MEVOTECH X-FACTOR BULLETIN

Labor Saver™: 2016-2002 GM 1500 Truck & SUV Front Lower Ball Joint (Cast Iron Control Arm)

Brand	Supreme	Product	Ball Joint	Date	December 2022
Part Number(s)	MK6541

Figure 1. Mevotech Supreme front lower ball joint MK6541 can be secured to the control arm easily via the included circlip (left) vs OEM stake/crimp method (right)

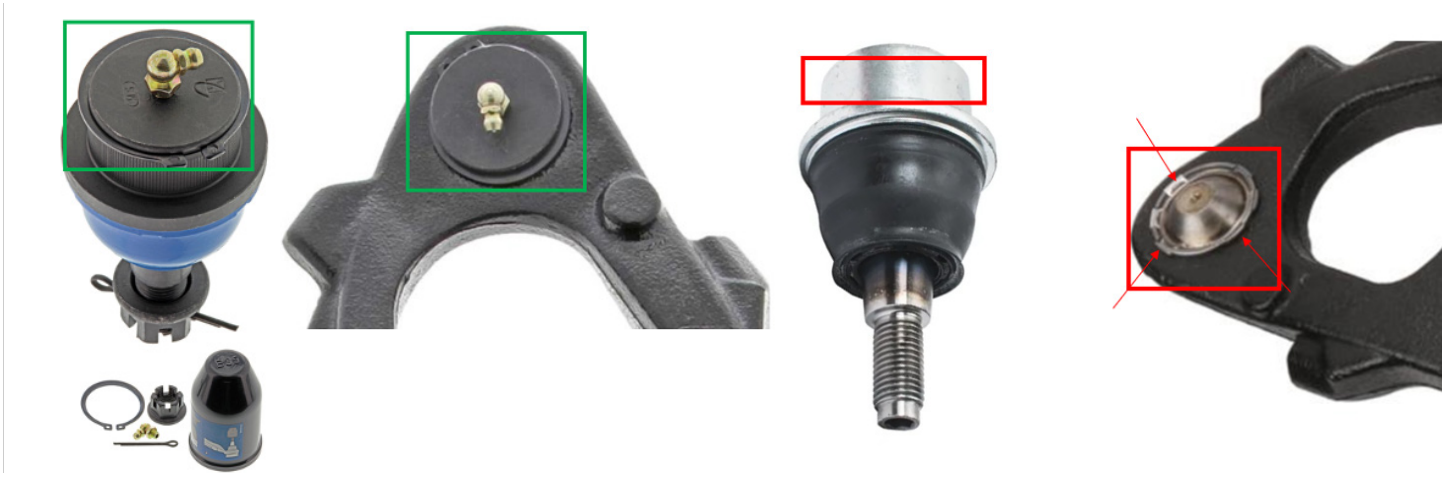
The OEM (PN: 19209396 and various other OE-style) front lower ball joints for the applications associated with the below listed part number require to be staked/crimped after press-in.

Mevotech Supreme front lower ball joint MK6541 is engineered to utilize a circlip as the supplementary retention method. This reduces installation time for the Professional Technician and is a frustration-free alternative to the staking/crimping method. Additionally, the potential of damage to the control arm body is limited when securing the ball joint after press-in. **See Figure 1**.
